**Re: Brownfield Restoration Ltd., licence application reference 204-1**

**SUBMISSION**

**SUBMITTED TO THE ENVIRONMENTAL PROTECTION AGENCY**

**WASTE LICENCE APPLICATION Ref. No 204-1**  
**AND**  
**SUPPORTING ENVIRONMENTAL IMPACT STATEMENT**  
**BROWNFIELD RESTORATION (IRELAND) LIMITED**  
**RELATING TO**  
**JOHN O'REILLY SAND AND GRAVEL QUARRY**  
**WHITESTOWN LOWER**  
**DONARD Co WICKLOW**

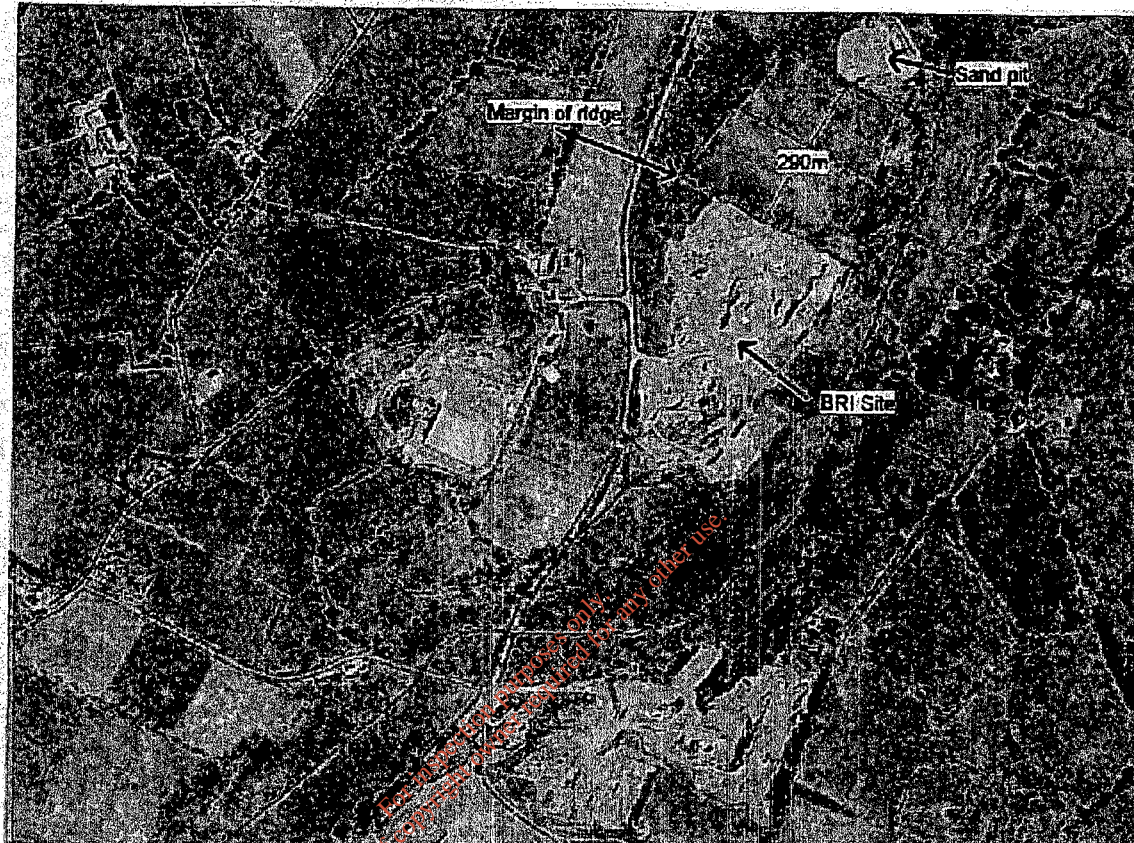
With regards to the proposed future treatment of leachate at Wicklow County Council's wastewater treatment facility in Baltinglass, the EIS provides no indication of how the proposed leachate volumes in m<sup>3</sup> relate to the existing and future capacity of the wastewater treatment plant, which are generally expressed in Population Equivalent (P.E). The nature of the leachate (*i.e.* BOD5 characteristics) will change over the lifetime of the landfill. The EIS does not provide any indication of how the changing characteristics of the leachate will impact on the annual capacity of the treatment plant. Neither has the EIS provided any evidence to illustrate that the plant at Baltinglass will be capable of adequately treating the leachate within the facility.
